# PRODUCT CHANGE NOTICE

1. TITLE <b>IRHMS57260SE Electrical Characteristics</b>		2. DOCUMENT NUMBER <b>FV5-C-19-0009</b>
		3. DATE <b>November 19, 2018</b>
4. MANUFACTURER AND ADDRESS <b>International Rectifier HiRel Products, Inc 205 Crawford Street Leominster, MA 01453</b>		5. MANUFACTURER PART NUMBER <b>See below for IR Part Numbers</b>
		6. BASE PART <b>NA</b>
		7. NATIONAL STOCK NUMBER (NSN) <b>NA</b>
8. CAGE <b>69210</b>	9. EFFECTIVE DATE <b>November 19, 2018</b>	10. GOVERNMENT NUMBER <b>NA</b>
11. POINT OF CONTACT <b>Manufacturer's Representative or Account Specialist (978) 534-5776</b>		12. DRAWING NUMBER <b>NA</b>
		13. SPECIFICATION NUMBER <b>MIL-PRF-19500/685</b>

## IRHMS57260SE [JANSR2N7476T1]

200V, N-Channel, TID Hardened MOSFET in a TO-254AA package

ELECTRICAL CHARACTERISTICS @  $T_j = 25^\circ\text{C}$   
Change Fig 8. Maximum Safe Operating Area

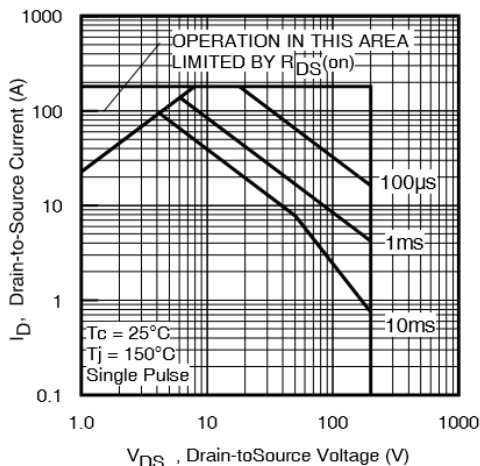
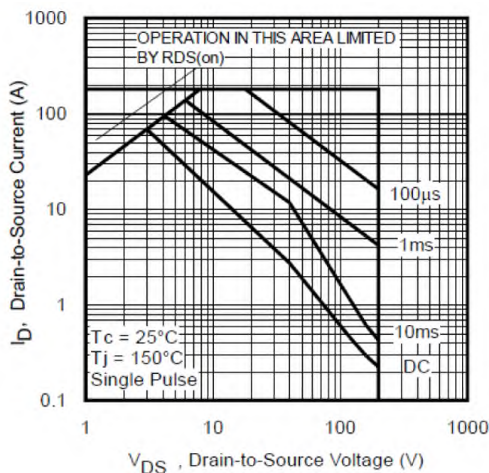
This GIDEP PCN is to announce SOA specifications change/update with the datasheet for the following International Rectifier Part No. Note that this change is related to part specification only, and not due to a die physical change.
